CITY OF RICHMOND

REPORT TO COMMITTEE

TO: Planning Committee
FROM: Joe Erceg
Manager, Development Applications
RE: **Application by Platinum Management Inc. for Rezoning at 6731 and 6751
Cooney Road from Townhouse District (R2) to Comprehensive Development
District (CD/121)**

TO PLANNING - May 8, 2001
DATE: April 18, 2001
FILE: 8060-20-7229

SITE PLAN
SCALE 1/8"=1'-0"

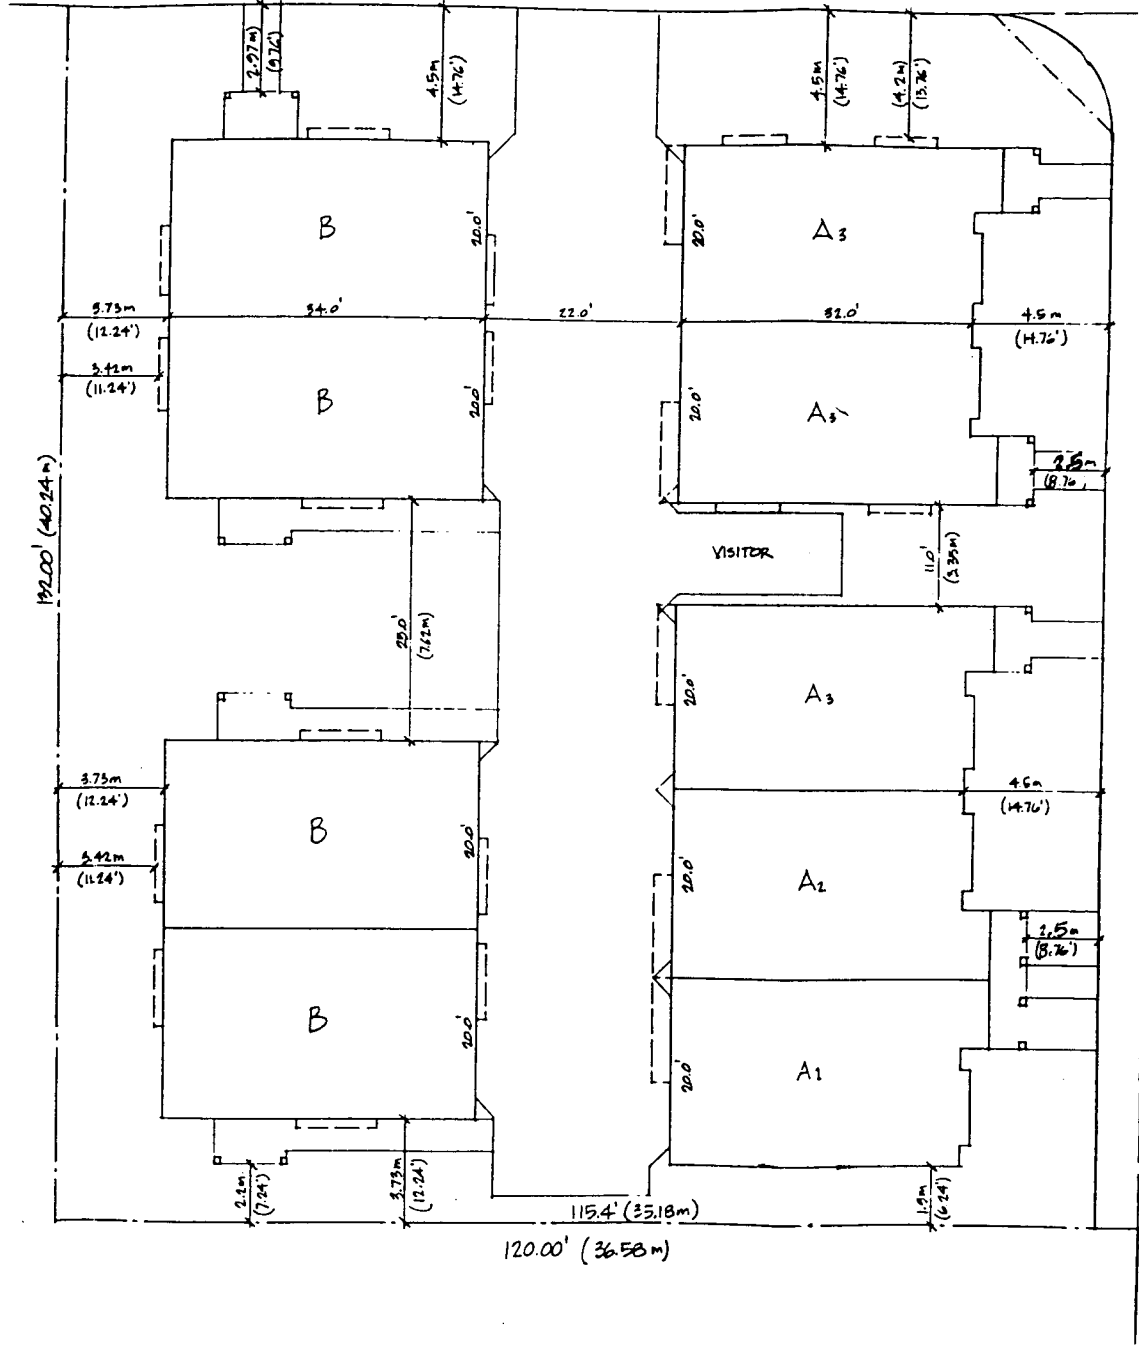
The proposed driveway location on Park Road is acceptable. A covenant should be put in place to ensure that no vehicular access is permitted along Cooney Road.

The developer has selected to provide 2 parking spaces per dwelling unit for the use of residents, rather than the 1.5 spaces per unit more typical of downtown residential projects. On this basis, staff are supportive of the visitor parking relaxation (0.1 car per unit versus 0.2 cars per unit) proposed under CD/121. In addition, staff have reviewed the development and are supportive of the proposal to reduce (under CD/121) the project's driveway width from the standard bylaw requirement of 7.5 m (24.61 ft) to 6.7 m (22 ft). Note, however, in light of the narrower driveway, attention should be paid at Development Permit stage to ensure adequate visitor stall, garage, and garage door widths to facilitate convenient vehicle manoeuvring.

The subject application underwent preliminary review (e.g. rezoning stage review) by Richmond's Design Panel on April 4, 2001. The consensus of the panel was that the project should proceed on to Development Permit. A number of issues were identified for the applicant to address at this next stage, including possible vehicle manoeuvring difficulties resulting from the reduced driveway width, poor visibility to the rear units, roof slopes, poor pedestrian access into the site from Cooney Road, and the need to enhance the appearance of the garage doors.

With regard to design issues, the proposed project is broken up into four blocks of three-storey townhouses, three of which are side-by-side duplexes and one of which is a triplex. Six of the nine proposed units will front directly onto either Cooney Road or Park Road, while two will be accessed via the project's shared, central open space. The advantage of this form to the developer is that he can offer a housing option that is visually appealing, close to downtown amenities, and achieves a relatively high buildable density (e.g. 0.9 floor area ratio), while still providing features common to lower density City Centre townhouse projects (i.e. units with windows on 2 or even 3 sides, private two-car garages, private entrances facing the street, etc.). The advantage to the City of this form is that it contributes to a broader range of housing choices in the downtown and provides a more interesting, pedestrian-friendly streetscape than has been developed in this area under Townhouse District (R2) (e.g. the subject site's current zoning designation). In addition, the three-storey height of the proposed development and its slightly raised, landscaped front yards will be a good "fit" with the larger scale projects anticipated in the neighbourhood over the medium- to long-term.

- a) Consolidate the two subject lots into one parcel (which will require demolition of one or both existing houses or an alternative legal arrangement;
- b) Dedicate a 1.4 m (4.59 ft) wide strip of land along its entire Cooney Road frontage for future road widening;
- c) Dedicate a 4 m by 4 m (13.12 ft by 13.12 ft) corner cut at the site's Cooney and Park Road corner; and
- d) Register a restrictive covenant against the subject site ensuring that vehicular access will be limited to a specific location on Park Road and no access will be permitted along Cooney Road.
